Access Compliance Report Public Rights-of-Way (Curb Ramps)

Main Street: TUBEROSE_ST Cross Street: CLEOME_ST Location: SW

ADA ID: RPAT211029131118 Ramp Type: Type 4 - Parallel Initial Pass/Fail: Pass Overall Compliance: No Severity Score: 20

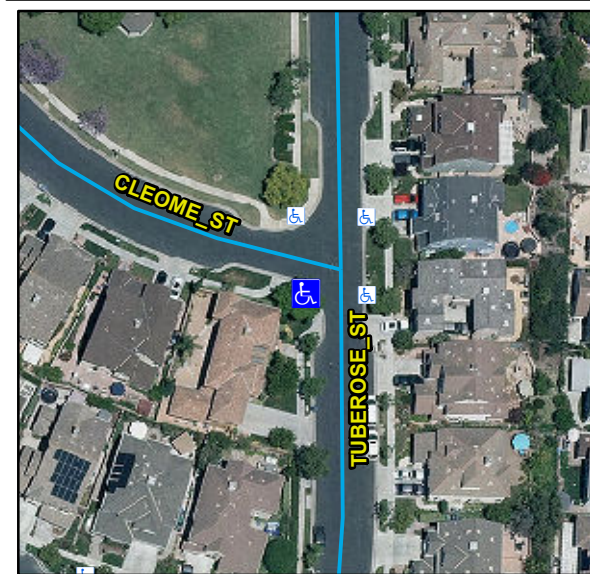
Crossing 1 Slope (%)	2		Crossing 2 Slope (%)	0.6
	Crossing 1 Cross Slope (%)	1.2		Crossing 2 Cross Slope (%)	1.4
No	Gutter Ponding	Yes	No	Curb Slope	9.4
Yes	Gutter Lip Height (in)	0		Road Run Slope (%)	2.3
No	Gutter Run Slope (%)	6.5		Road Cross Slope (%)	0.3
Yes	Gutter Cross Slope (%)	1.2	No	Perpendicular Joint Present	No
Yes	Overall Surface Condition	Acceptable			
	Cross Gutter Present?	No		Spandrel Present?	No
	Replace Cross Gutter?	N/A		Replace Spandrel?	N/A

Possible Solutions:
Remove & Replace Curb Ramp With Two New Directional Ramps or Equivalent. Remove & Replace Gutter.
